NAME "EMMY"..... REPORT Lon. No. 110408

of the Chief Ship Surveyor are desired on this case for the consideration of the Classing Committee.

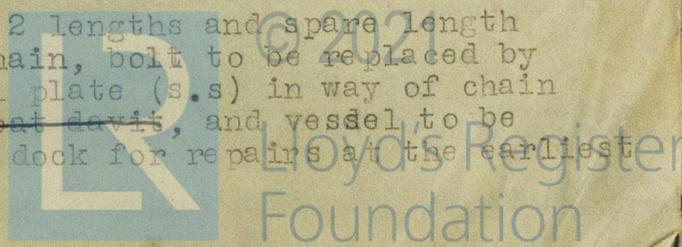
It is submitted the vessel appears worthy to remain as classed and to have record of docking survey 4,42 subject as recommended and to indented bottom shell plating etc. abaft No.1 D.B. tank, fore side plating, frames, deck plating etc. (s.s) also upper deck hatch side coaming of Nos. 2 & 4 hatchways being permanently repaired at the first opportunity and to shell plate No.11 in 2nd strake below sheer (p.s) E.W. 10,39 being specially examined at the next dry docking and to the port bower anchor being tested and found of sufficient weight or replaced by another of proper weight and test at the first opportunity. (and to a bower anchor being supplied). Lifeboat davit to fair.
